**TRANSMITTAL OF RESPONSES TO THE OHIO ENVIRONMENTAL PROTECTION AGENCY  
COMMENTS ON THE PROJECT SPECIFIC PLAN FOR AREA 3A/4A SUBSURFACE  
PREDESIGN INVESTIGATION**

**RESPONSES TO OHIO ENVIRONMENTAL PROTECTION AGENCY COMMENTS  
ON THE PROJECT SPECIFIC PLAN FOR  
AREA 3A/4A SUBSURFACE PREDESIGN INVESTIGATION  
(20200-PSP-0005, REVISION 0)**

FIGURE 1-1. LOCATION OF AREAS 3A/4A

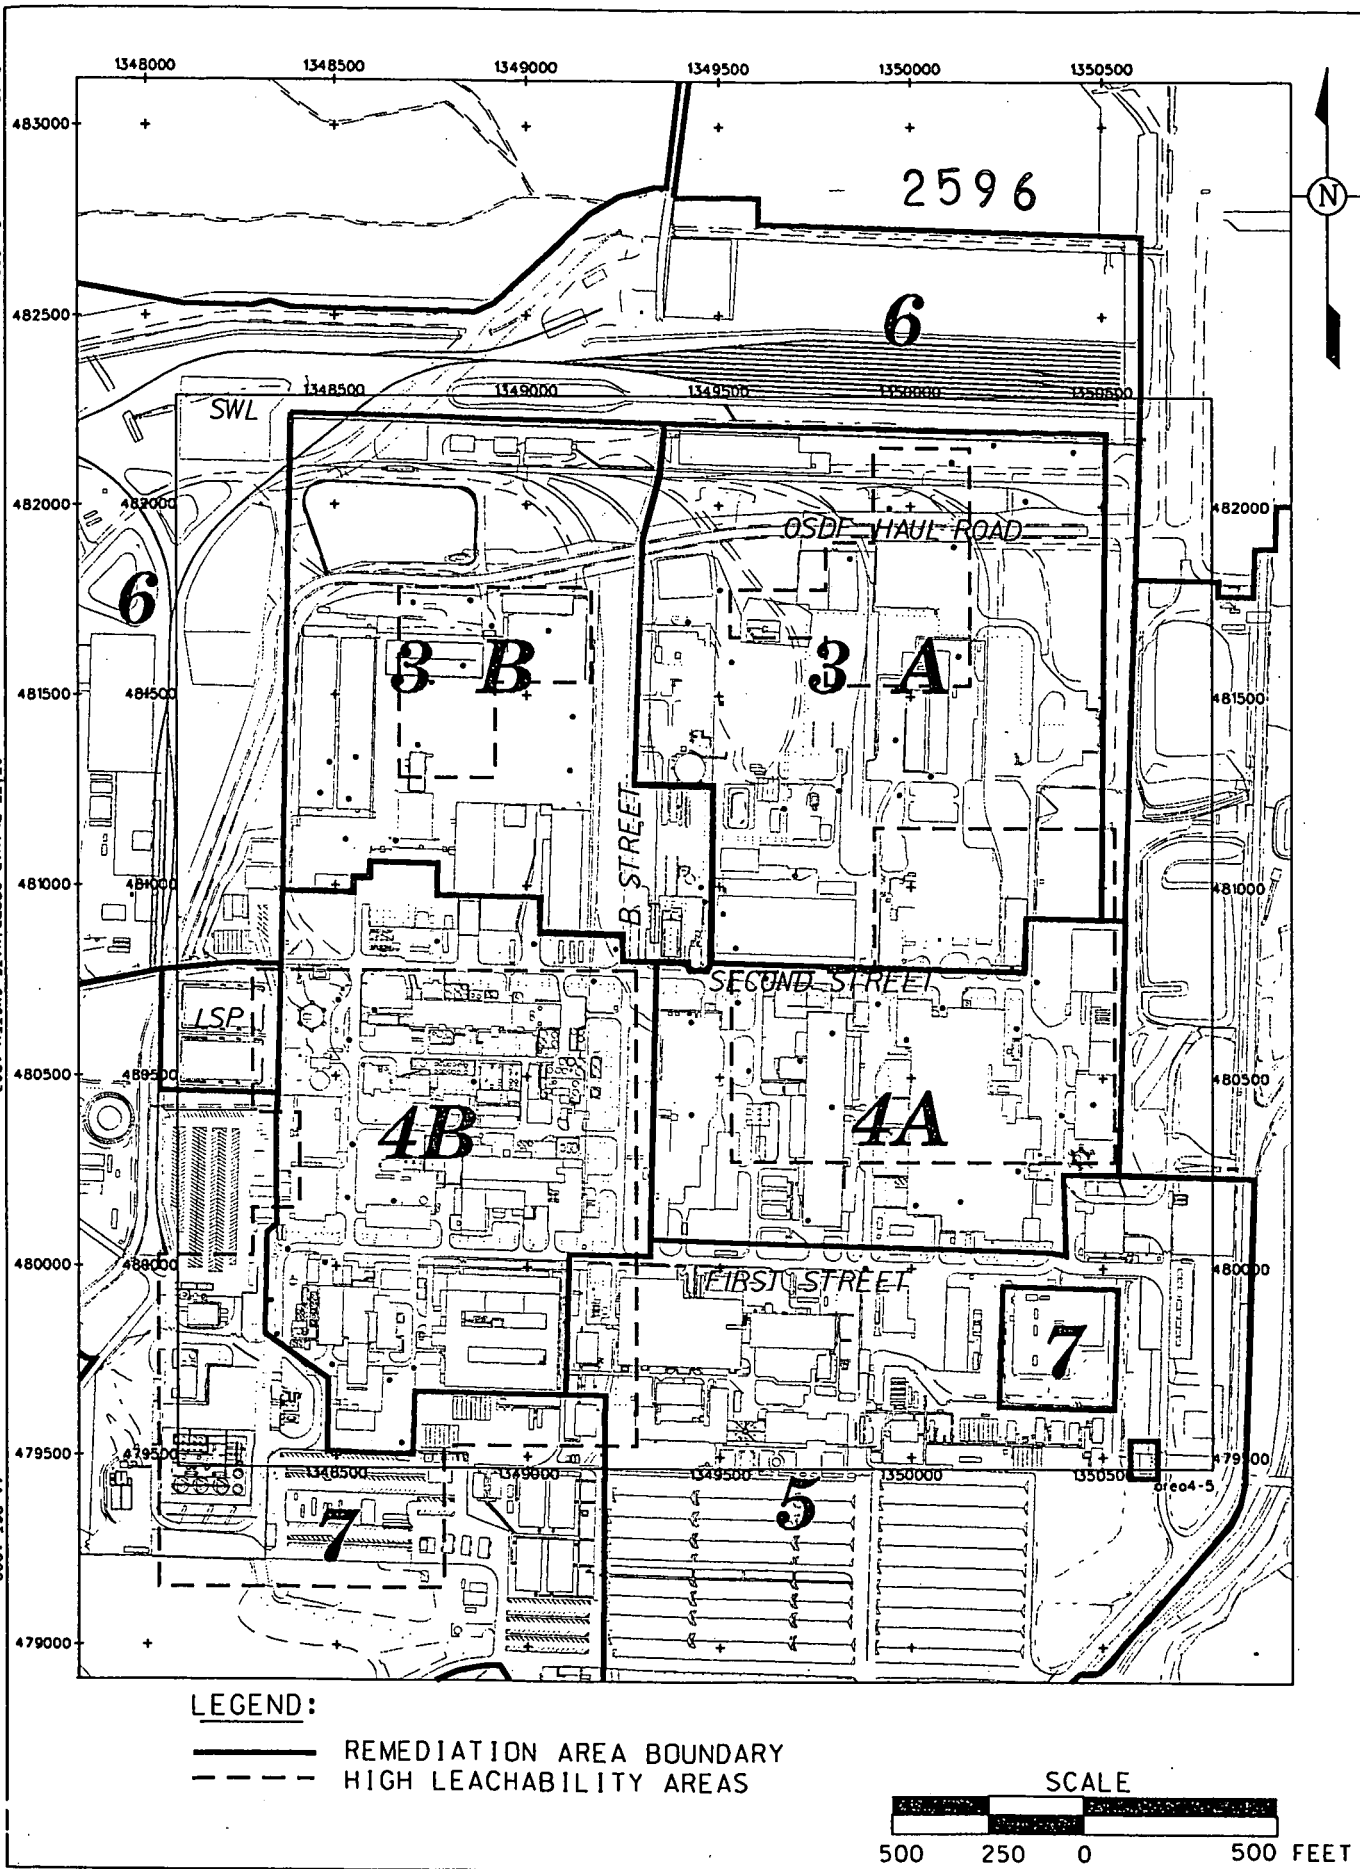
Commenting Organization: Ohio EPA  
Section #: 1.1                      Page #: 1-1                      Line #: Third Bullet                      Commentor: OFFO  
Original Comment #: 2  
Code: C  
Comment: Figure 1-1 does not show the high leachability areas in Area 3A/4A. Please correct.

Response: Agreed. The outline of the high leachability areas was inadvertently forgotten on Figure 1-1.

Action: A revised Figure 1-1 is attached to these comment responses. This revised figure will be included in a future Variance/Field Change Notice to the PSP.

FIGURE 2-1. ABOVE-WAC LOCATIONS, PROPOSED BORINGS AND EXISTING BELOW-WAC LOCATIONS NEAR PLANT 9

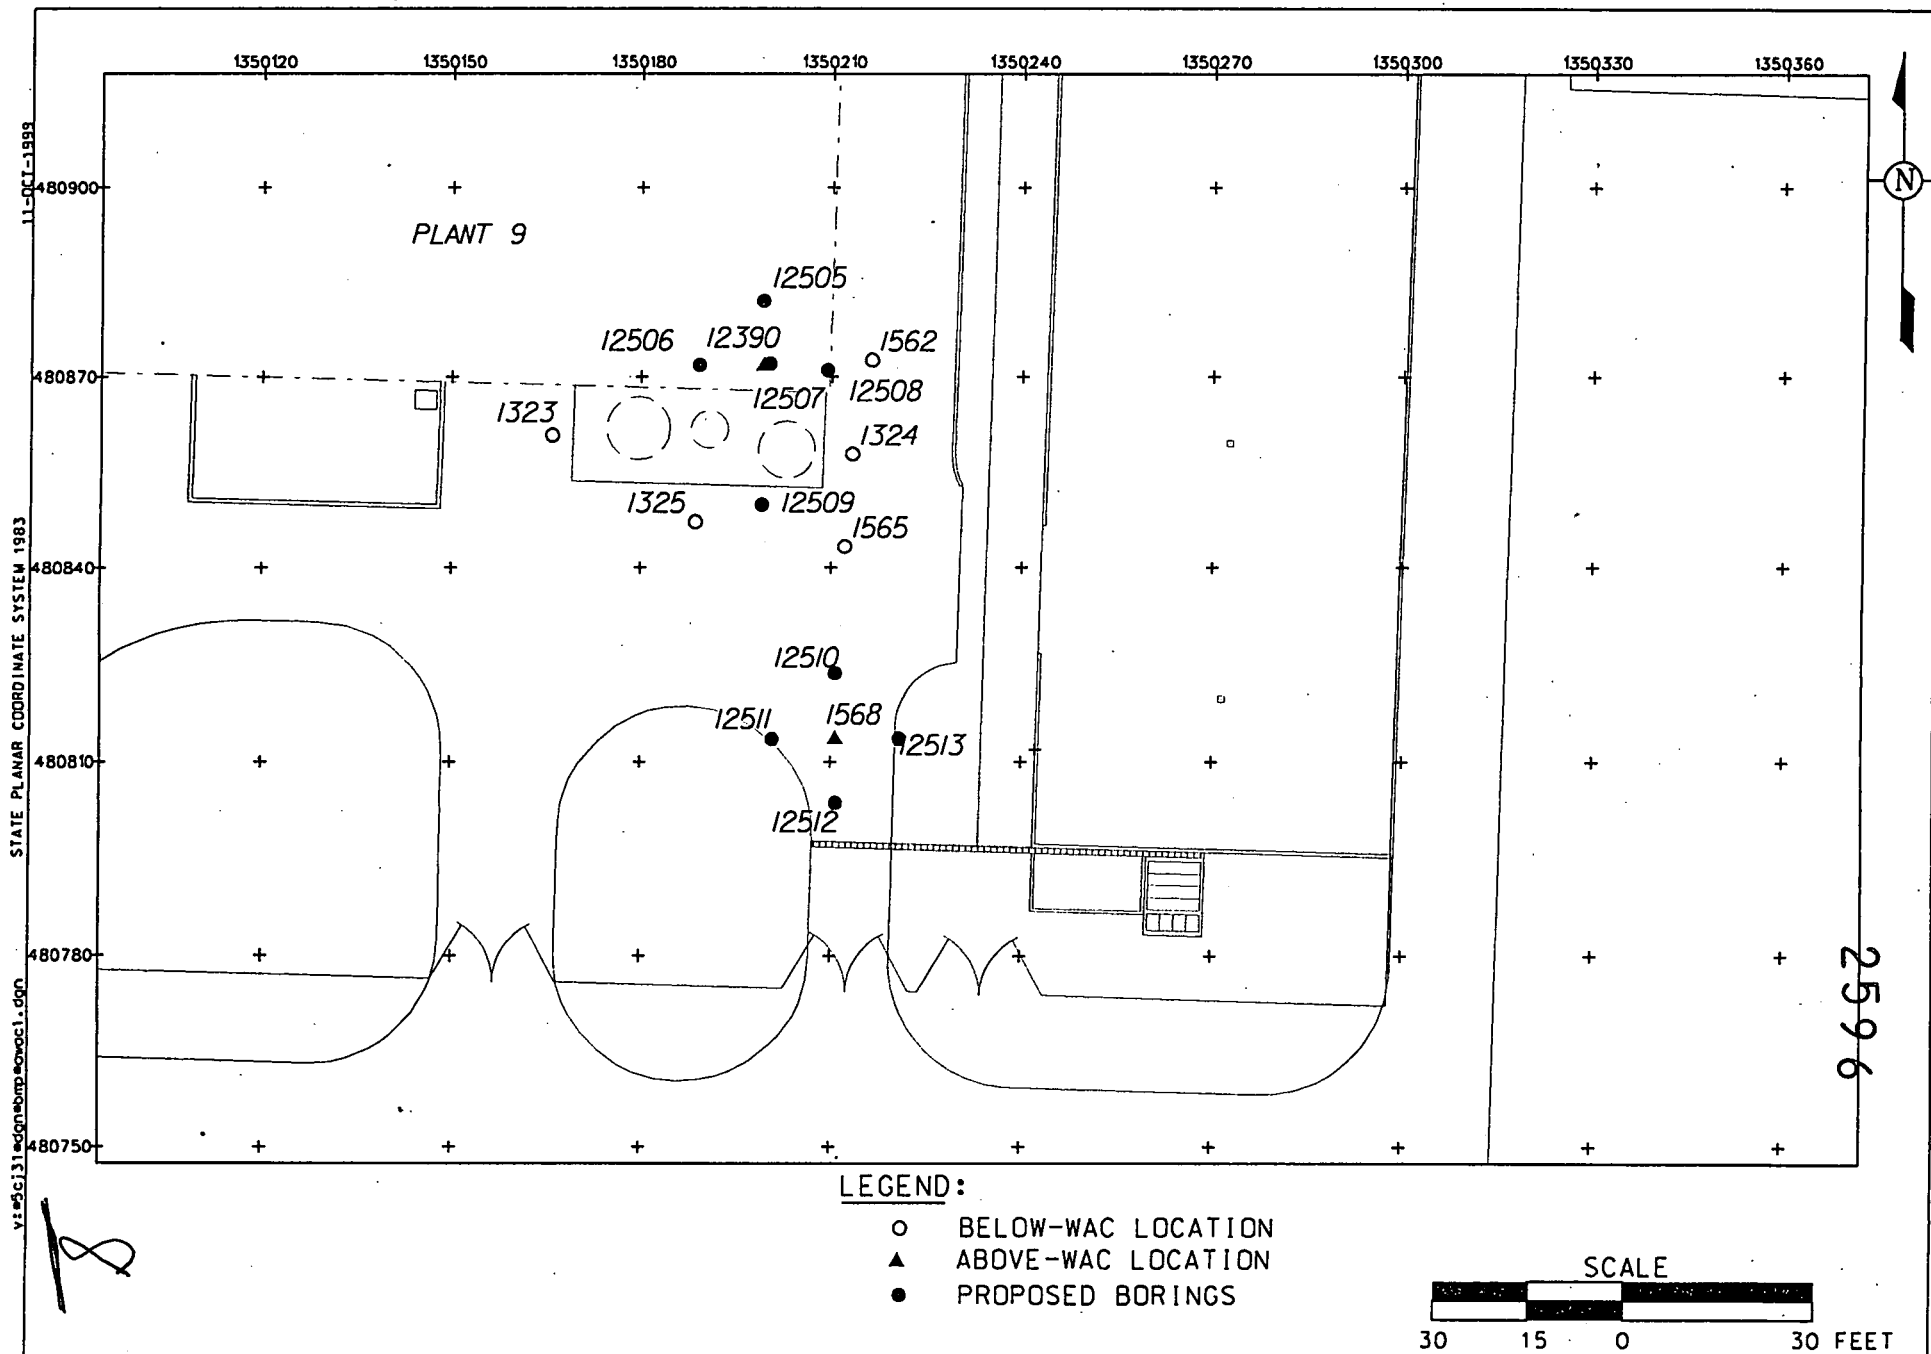
Comment: In Figure 2-1, boring #12486 is somewhat remote from the other locations proposed. Is this location based on historical data?

Response: Boring 12486 is a high-leachability boring (see Figure 3-2), not a proposed above-WAC boring. It was inadvertently included on Figure 2-1.

Action: A revised Figure 2-1 is attached to these comment responses. This revised figure will be included in a future Variance/Field Change Notice to the PSP.
